MAS004697 MCL 25-23

Circular Letter

MC20 Cielo - Serviceability of the fuel tank door lock

DATE: April 11, 2025

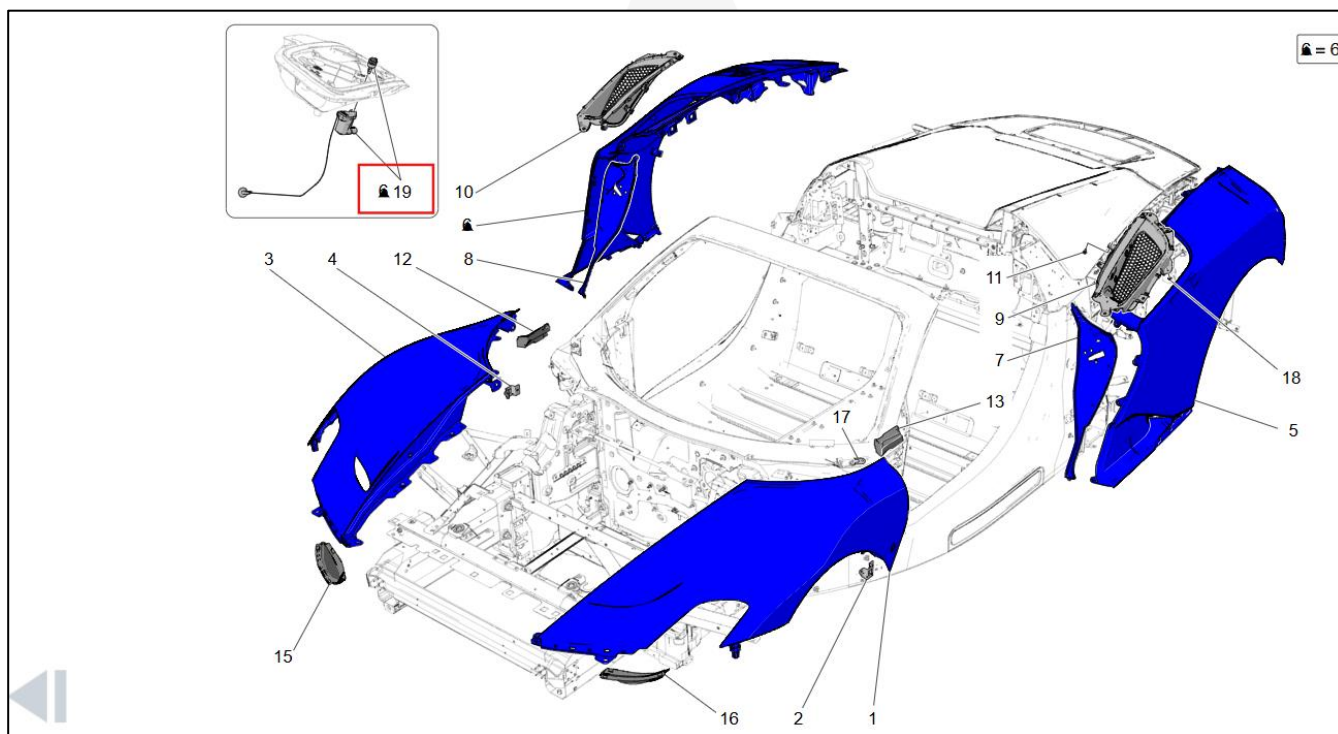
This communication is intended to provide important information on the serviceability of the fuel door lock/unlock mechanism. If you experience any problems, you can now replace it instead of the entire rear fender.

In few cases, it has been observed that it is not possible to open the fuel door due to a defective locking/unlocking mechanism.

- #670355090 = FUEL END CAP REPAIR KIT (Parts Catalogue -> Section #09.06-1 -> Item #19)

- #09.06.020 – FUEL TANK DOOR REPAIR KIT (0.50 h).
